Access Compliance Report

Public Rights-of-Way

(Curb Ramps)

Intersection ID: 10957	Main Street: CRISMAN_ST	Cross Street: PACIFIC_ST	Location: W
ADA ID: F207B5DECD72	Ramp Type: Perp	Initial Pass/Fail: Fail	Overall Compliance: No
		Severity Score: 10

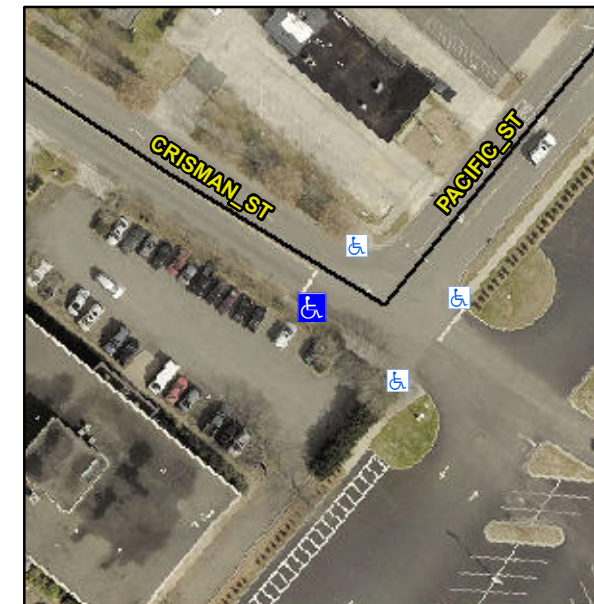
Not Found, R304.5.1, R304.5.3

Compliance	Description	Data	Compliance	Description	Data
N/A	Ramp Length (in)	73.0	Yes	Ramp Slope (%)	7.6
No	Ramp Width (in)	47.0	No	Ramp XSlope (%)	2.3
N/A	Flare Type LT	N/A	N/A	Flare Type RT	N/A
N/A	Flare Slope LT (%)	N/A	N/A	Flare Slope RT (%)	N/A
N/A	Flare Traversable LT?	N/A	N/A	Flare Traversable RT?	N/A
N/A	Landing Length (in)	N/A	N/A	DWS Provided?	N/A
N/A	Landing Width (in)	N/A	N/A	DWS Contrast?	N/A
N/A	Landing Slope (%)	N/A	N/A	DWS Length (in)	N/A
N/A	Landing X Slope (%)	N/A	N/A	DWS Full Width?	N/A
N/A	Landing Curb? (Y/N)	N/A	N/A	DWS Offset (in)	N/A
N/A	Shared Landing?	N/A			
N/A	Gutter Ponding?	N/A	N/A	Gutter Slope (%)	N/A
N/A	Gutter Lip Ht (in)	N/A	N/A	Gutter X Slope (%)	N/A
N/A	Painted X Walk1?	No	N/A	Painted X Walk2?	N/A
	X Walk 1 Direction	To NE		X Walk 2 Direction	N/A
N/A	X Walk 1 Width (in)	N/A	N/A	X Walk 2 Width (in)	N/A
	X Walk 1 Slope (%)	7.9		X Walk 2 Slope (%)	N/A
	X Walk 1 X Slope (%)	1.8		X Walk 2 X Slope (%)	N/A

Remove & Replace Entire Ramp.
